ALAMEDA COUNTY  
HEALTH CARE SERVICES

August 14, 2008

Subject: Fuel Leak Case No. RO0000107 and Geotracker Global ID T0600100451, Di Salvo Trucking, 4919 Tidewater Avenue, Oakland, CA 94601

Alameda County Environmental Health (ACEH) staff has reviewed the case file for the above-referenced site, including the most recent document entitled, "*Revised Remedial Action Plan, Former Disalvo Trucking, 4919 Tidewater Avenue, Unit B, Oakland, California, 94601,*" (RAP) dated July 15, 2008 and prepared on your behalf by ETIC Engineering. The RAP presents the results of a geophysical survey, proposes sampling soil and groundwater in 16 soil borings, and proposes the installation, development, and sampling of one monitoring well.

Attachment 1: Shoreline Area Sampling Locations

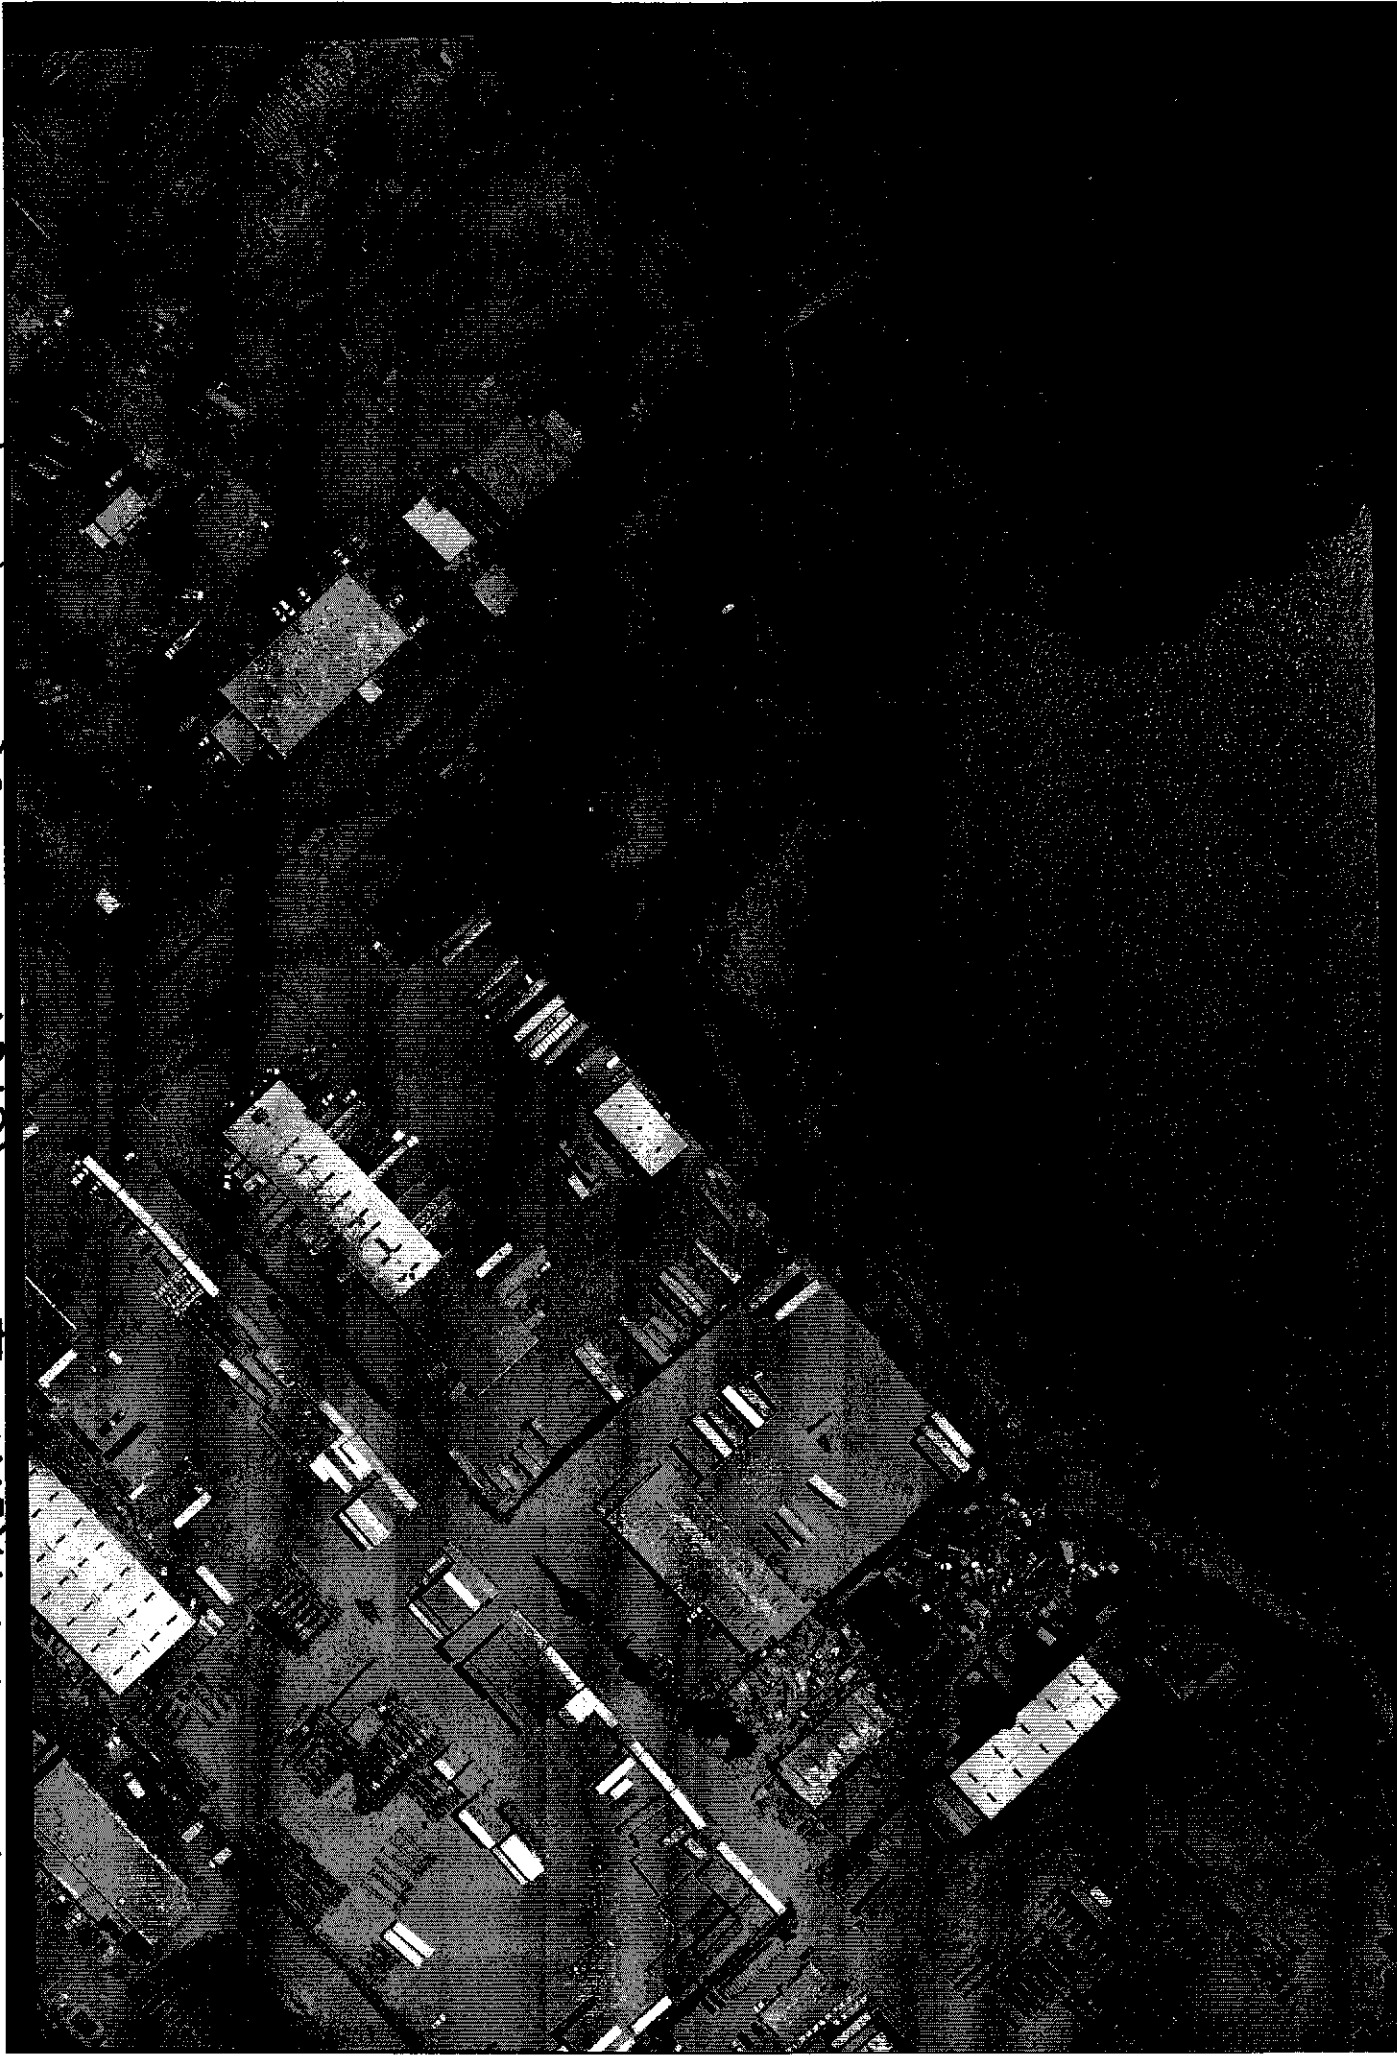
2. **Discharge to Surface Water.** Although three borings are proposed along the southern property boundary, the proposed borings will not directly evaluate whether groundwater contamination from the site discharges to surface water. Therefore, we request that you advance three soil borings along the shoreline area shown on Attachment 1. Soil and groundwater samples are to be collected according to the protocols proposed for the on-site soil borings. Please present the results in the Site Assessment Report requested below.
